**Government of India
Ministry of Railways
Research, Designs & Standards Organisation
Manak Nagar, Lucknow - 226 011**

No. EL/3.2.30

MODIFICATION SHEET NO. RDSO/WAM4/161

Replacement of cast iron transition resistances (RGR) by stainless steel transition resistances in tap changer Type No. 32 of M/s HBB make.

SK EL-4031

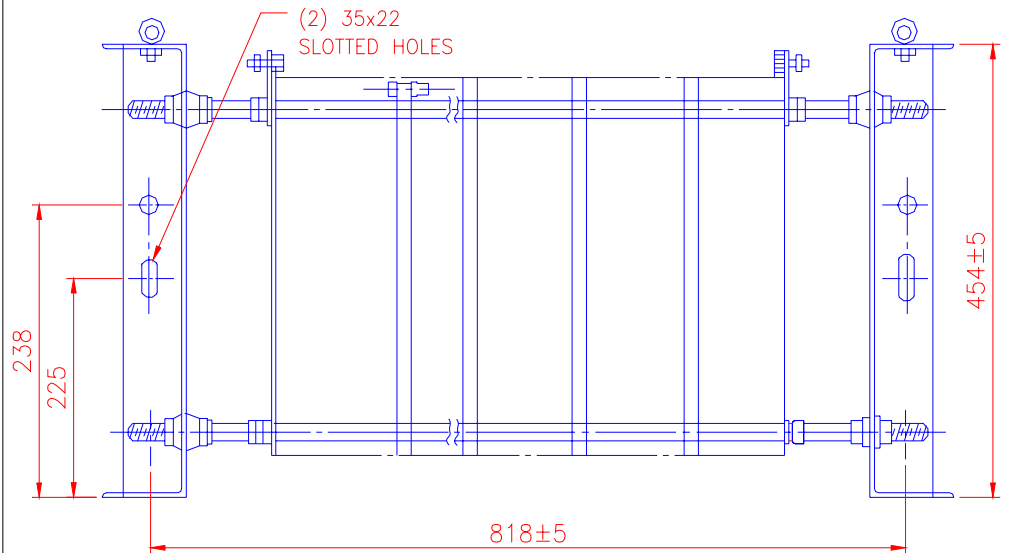
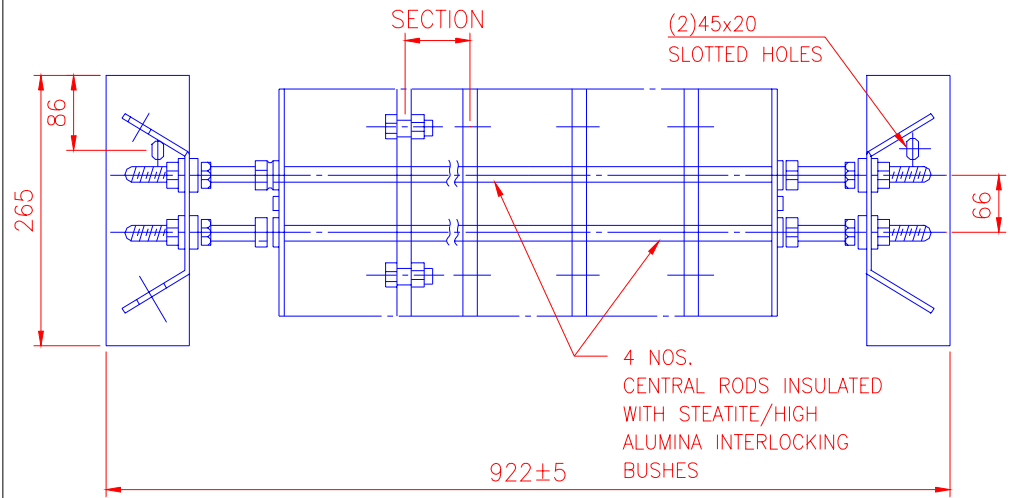
Replace the existing CI RGR with stainless steel RGR.

- (12) Interchangeability shall be possible with existing CI grid resistor assembly without any modification.
- (13) Overall general arrangement and broad details of SS grid RGR shall be as per RDSO SK EL 4031.

- (1) The grids shall be punched from cold rolled SS sheet Grade AISI 304 at least 1.2 mm thick and maximum 230 mm. wide.
- (2) The minimum intergrid spacing shall be 12 mm.

- (3) The intergrid connection of each section shall be through spot welded SS links. The spot welding shall be done by a precision spot welding machine pneumatically operated and having a timer and electronic control.

- (4) The total assembly of grids shall consist of 6 to 8 sections (with welded links). These sections shall be bolted to each other by using spring washer/check nut and the current shall flow through copper spacers.

- (5) The intergrid connections shall be through two parallel paths.
- (6) All hardwares used shall be of high tensile steel.
- (7) The grid shall be sturdy and suitable stiffeners shall be provided.

- (8) The grids shall be mounted on four ceramic insulating rods.
- (9) The mounting rods and the grids shall be insulated by High Alumina/Steotite Interlocking Bushes.

- (10) The secondary insulation between the mounting rod and the bracket shall be through round glazed porcelain insulators and Hylam Tube.
- (11) The end terminals shall be of copper suitably connected with the end grids and supported on the mounting rods.
